**GOVERNMENT OF THE DISTRICT OF COLUMBIA
DEPARTMENT OF CONSUMER AND REGULATORY AFFAIRS
OFFICE OF THE ZONING ADMINISTRATOR**

Re: Zoning PDRM – 2012 Kalorama Road, NW – Subject Property

Please allow this letter (and attached graphic Zoning Analysis) to serve as a confirmation of our conversation on Thursday, October 11th, 2012 regarding the proposed development at the subject property. The conclusions that we discussed are summarized below:

Board of Zoning Adjustment
District of Columbia
CASE NO.18540
EXHIBIT NO.5

DRAWING TITLE
 ZONING ANALYSIS

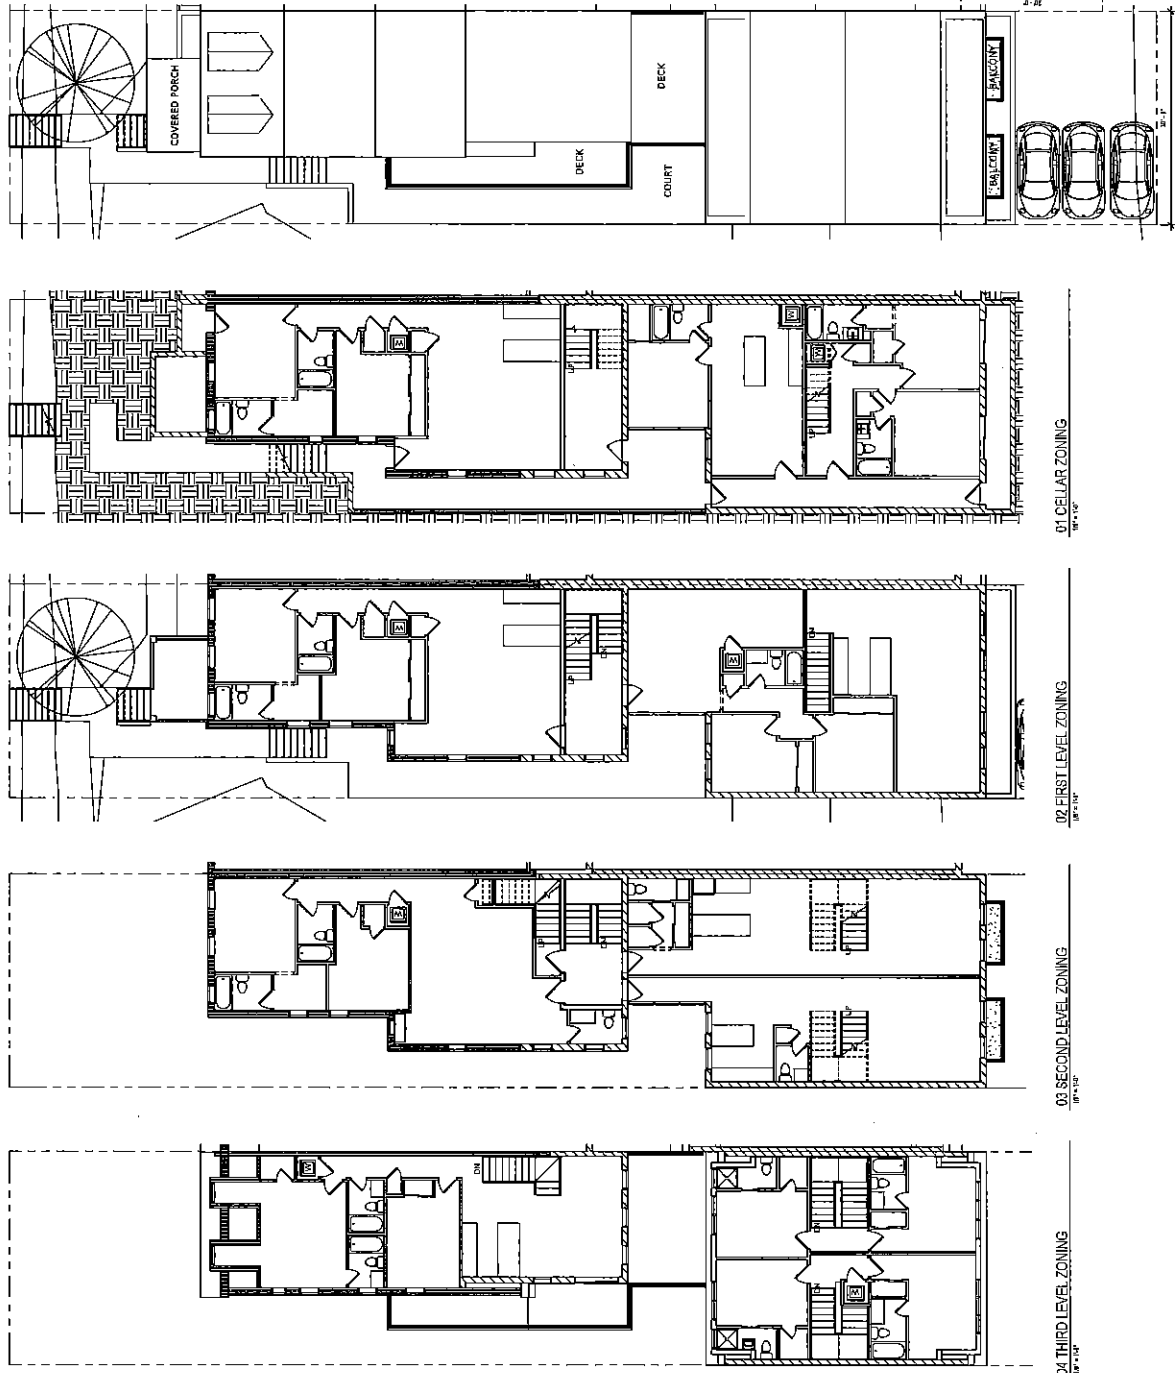
- 1 - The building is a matter-of-right conversion from a single-family dwelling into an eight unit apartment building in an R-5-B zone.
- 2 – The building height shall be established by measuring from the top of the top of the curb surface opposite the middle of the front of the building, to the top of the roofing surface or the top of the highest parapet, whichever distance is greater.

- 3 – The lowest level of the building shall be determined to be a basement or a cellar based on the difference between the top of the adjacent grade and the surface of the ceiling at that level. If this dimension is less than 4', or the 2'-5" that is proposed, it will be deemed to be a cellar. In the case of a limited areaway to access the level, the top of the grade adjacent to the areaway shall be used.

- 4 – The FAR calculation for the building exempts a cellar from the calculation; The cellar will not be counted towards the F.A.R. of the building.
- 5 – The existing parking spaces of the building will be maintained and will be grand-fathered into the proposed building. Proposed parking will maintain the existing three parking spaces at the rear of the building and off of the public alleyway and will provide a total of three parking spaces for the entire building and are to be maintained at their current location and configuration. The dimensions of these spaces shall maintain the minimum dimensions in both directions.

- 6 – The open courtyard which is surrounded by walls on three sides will extend from the lowest level up thru the roof and will be open to the sky. The courtyard is to be a minimum of 10'-0" in either direction and will be considered a legal open court.

7 – The existing non-conforming side yard will be eliminated through the introduction of a conforming open court at the termination of the side yard.

8 – The areaway leading to the open court and the open court itself shall not be used in the calculation of lot coverage.

9 – Inclusionary zoning shall not be required as a net increase of seven units are being proposed.

Accordingly, when you file the plans for a building permit, I will approve drawings that are consistent with the plans attached to this letter. Please let me know if you have any further questions.
